MFN 09-298

Docket No. 52-010

Subject: **Partial Response to NRC RAI Letter No. 315 Related to ESBWR Design Certification Application – DCD Tier 2 Section 3.6 – Protection Against Dynamic Effects Associated with the Postulated Rupture of Piping; RAI Numbers 3.6-6 S03 parts a, c & d, 3.6-13 S02 and 3.6-16 S02**

**Partial Response to NRC RAI Letter No. 315
Related to ESBWR Design Certification Application –
DCD Tier 2 Section 3.6 –
Protection Against Dynamic Effects Associated
with the Postulated Rupture of Piping;
RAI Numbers 3.6-6 S03 parts a, c & d,
3.6-13 S02 and 3.6-16 S02**

Figure 3.6-3. Typical Terminal End Break at Containment Penetration

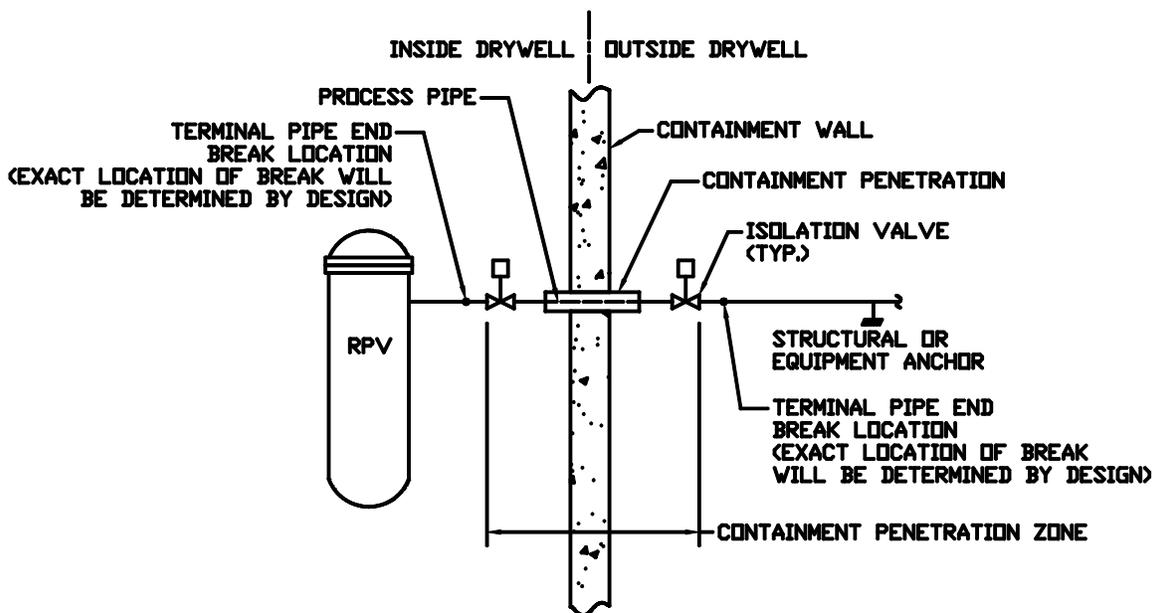
GEH provides two tables of terminal end pipe break locations. It appears that these lists may not be complete. For an example, it does not include terminal end pipe break locations at some pipe anchors that act as rigid constraints to pipe motion and thermal expansion. It should be noted that GEH has assumed the pipe element between the containment penetration as anchor point in its ESBWR main steam piping analysis that was previously provided to the staff during its main steam piping design review. However, the staff noted that containment penetration is not considered as anchor point in the tables included in this RAI response. GEH is requested to clarify this inconsistency and also explain how its criteria are consistent with the terminal end defined by Note 3 on Page 3-4-5 of BTP 3-4. In addition, GEH is requested to modify the DCD to clarify that all ESBWR piping design will be designed to minimize the stresses and fatigue usage factors such that piping intermediate pipe break locations are avoided as stated in this RAI response. The staff noted that criteria for postulating intermediate break are still included in the DCD Revision 5. Finally, pending final resolution of this RAI, GEH should include these pipe break location tables in a revised DCD.

Consistent with BTP 3-4, Note 3 on Page 3-4-5, GEH agrees with the NRC that terminal end breaks will need to be postulated at the containment penetration. A table (Table 3.6-7) will be added in DCD Tier 2, Chapter 3.6, to identify the terminal end breaks at the containment penetration for all high energy piping inside and outside the containment boundary. In addition, GEH will also add a figure in DCD Tier 2, Chapter 3.6, to clarify typical terminal end break locations inside and outside of the containment penetrations.

a) DCD Tier 2, Chapter 3.6, is being revised in Revision 6 to add Table 3.6-7 and Figure 3.6-3, as shown in the attached markup.

b) DCD Tier 2, Chapter 3.6, Section 3.6.2.1.1 is being revised in Revision 6 to add a statement with regard to the addition of the Figure 3.6-3, as shown in the attached markup.

d) DCD Section 3.6.2.1.1 is being revised in Revision 6 to add the statement, "*including the locations shown in Fig. 3.6-3*" to the terminal end bullet.

The terminal end pipe break locations for high energy lines inside and outside containment are provided in Tables 3.6-5 and 3.6-6. The high energy line breaks at the containment penetration outside of the containment penetration zone are provided in Table 3.6-7. Terminal end break locations in piping systems on both sides of the containment penetration are shown in Figure 3.6-3.
